### **Clause 4.6 – Exceptions to Development Standards**

**Property:** 364 – 374 Canterbury Road, Canterbury

**DA Number:** DA – 505/2014

**Re:** Amended Plans and Clause 4.6 Variation – Height of Buildings

104

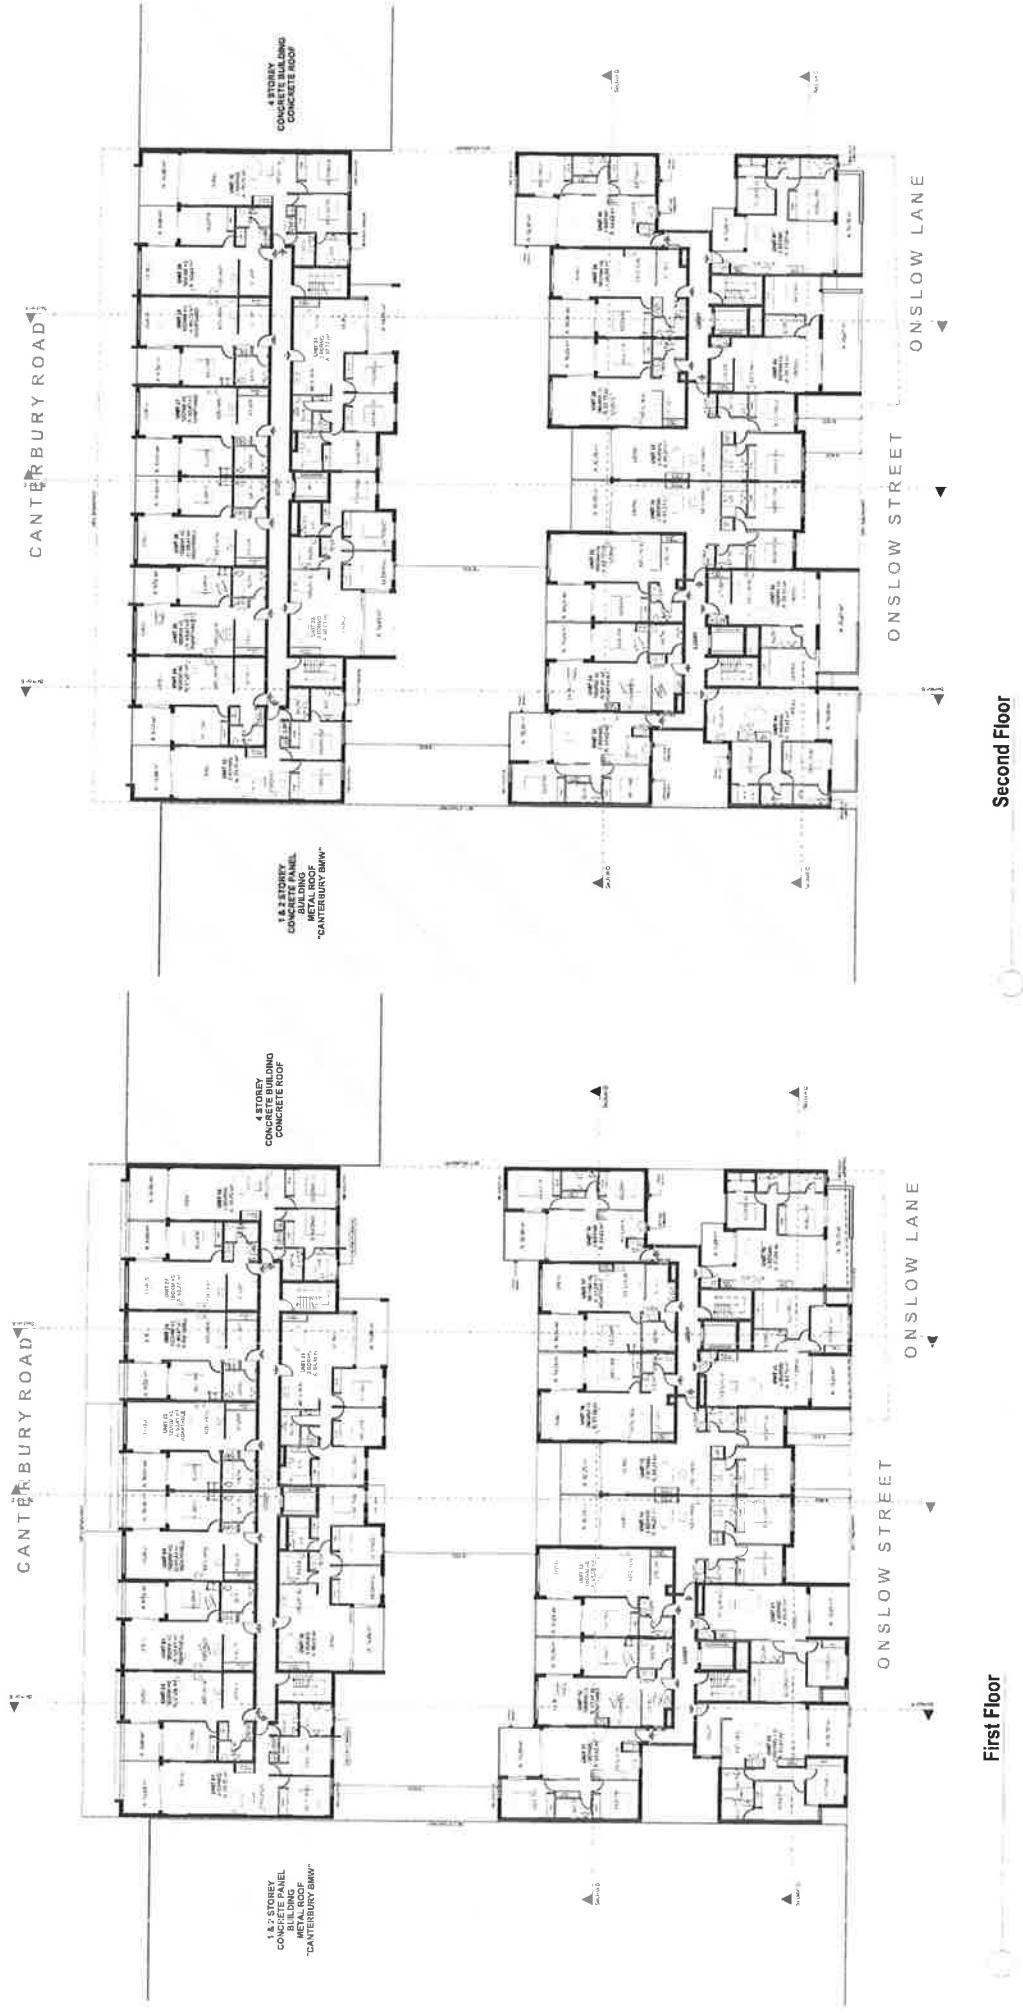
Plans 104 and 105 Issue E prepared by Mackenzie Architects International shows the modifications to the 5<sup>th</sup> and 6<sup>th</sup> storey to achieve a minimum 18m separation between the residential units on the front and rear building. The modifications includes the deletion of units on the rear building and modification to the units on the front building to 1 bedroom units.

DRAWING NO.			
A 200			
E			
DRAWING SECTION			
A			
RESCO			
PROJECT NUMBER			
364-374 Canterbury Road, CANTERBURY NSW 2194,			
DRAWING NUMBER			
SECTION - A

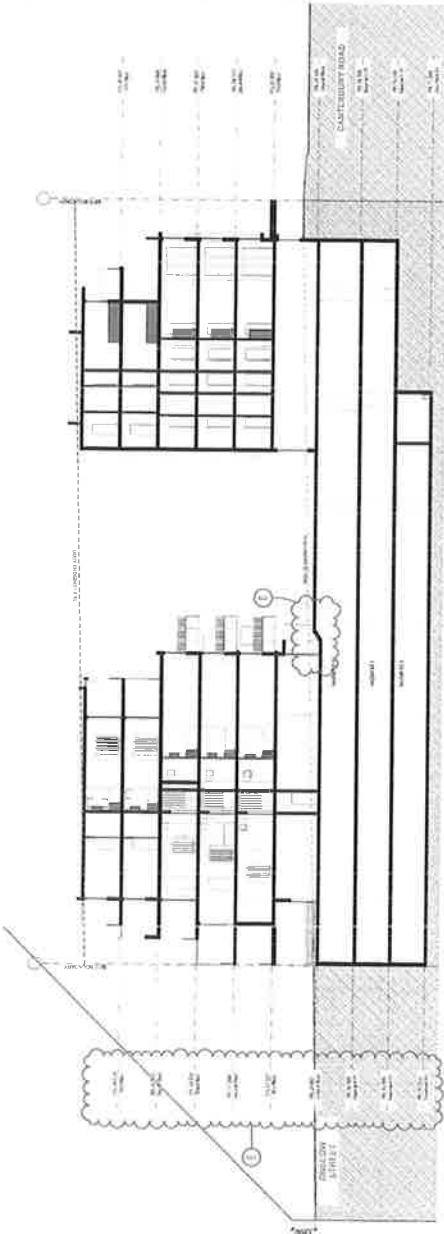
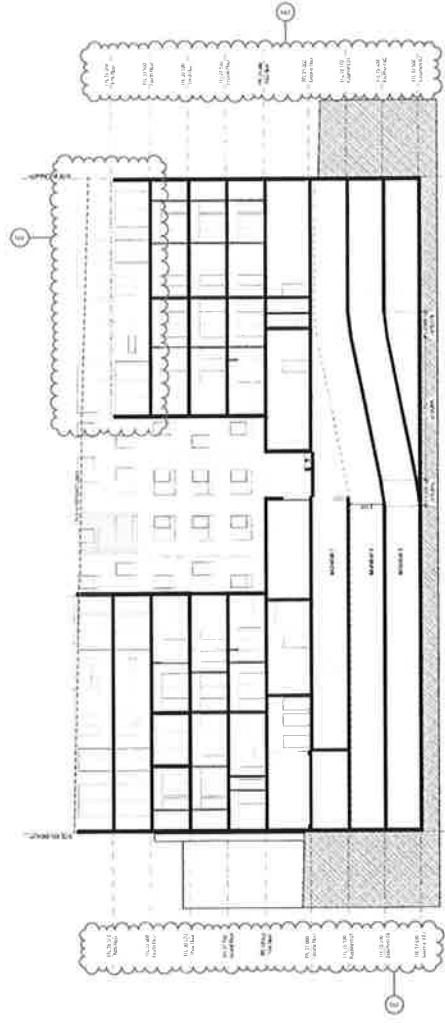
The building height plane and amended building is shown on Section A and B plan No. 200 prepared by Mackenzie Architects International.

The lift overrun has been reduced in height to 2.4m above the upper roof level and this is shown on Section A plan No. 200 prepared by Mackenzie Architects International.
